Q-312

SVE BULLETIN

QVM BULLETIN: Q-312 DATE: 28 / May / 2020

SEIC Customer Access Circuit Label Information Correction

LABEL LOCATION

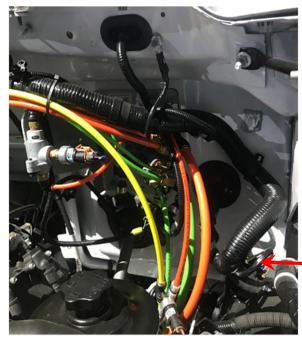
On current production vehicles the Customer Access Circuit Label on the under-hood wiring harness is indicates incorrect circuit information. Below is a cross-reference chart to aid with identifying correct wire circuit color for wiring the SEIC controls.

This will remain the alternative solution until the label correction change can be put into production on or about July 2020 (Estimated, subject to change without notice).

OHAITI			
	CURRENT LABEL	NEW LABEL	
CIRCUIT	(Incorrect)	(Correct)	
CE933 (Diesel)	BU-OG	BU-GN	
CE326 (Diesel)	BU-WH	BU-GY	
VMC05 (Diesel)	VT-OG	VT-WH	
LE424 (GAS)	YE-WH	YE-GN
